# **Probability of Missile Generation from Low Pressure Turbines**

**Non-Proprietary Version**

**June 2013**

**Figure 2.1-1 Typical Integral Rotor Material Test Locations**

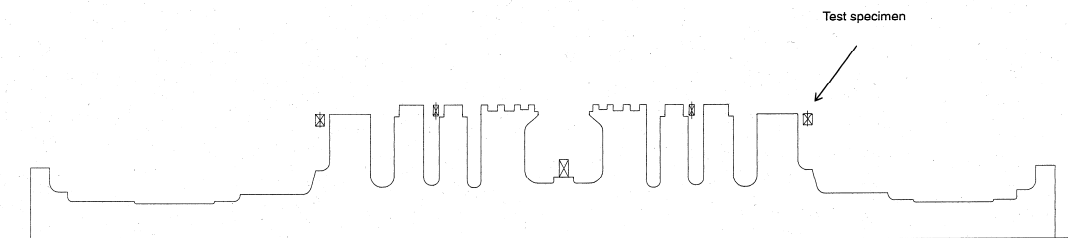
Revision	Page	Description
	2.1-1	<p>The second paragraph is modified as follows.</p> <p><u>“The specification for the integral rotors requires testing at the locations shown in Figure 2.1-1 to confirm uniformity of the rotor.– Using these specimens, the tensile test (tensile strength, yield strength, elongation and area reduction) and Charpy test (Charpy V-notch energy, 50% FATT and upper shelf energy) will impact test (absorbed energy, 50% FATT and upper shelf energy) shall be performed to and confirm that if the required <math>K_{IC}</math> of [ ] and the other mechanical properties used in this report specifications are satisfied.”</u></p>
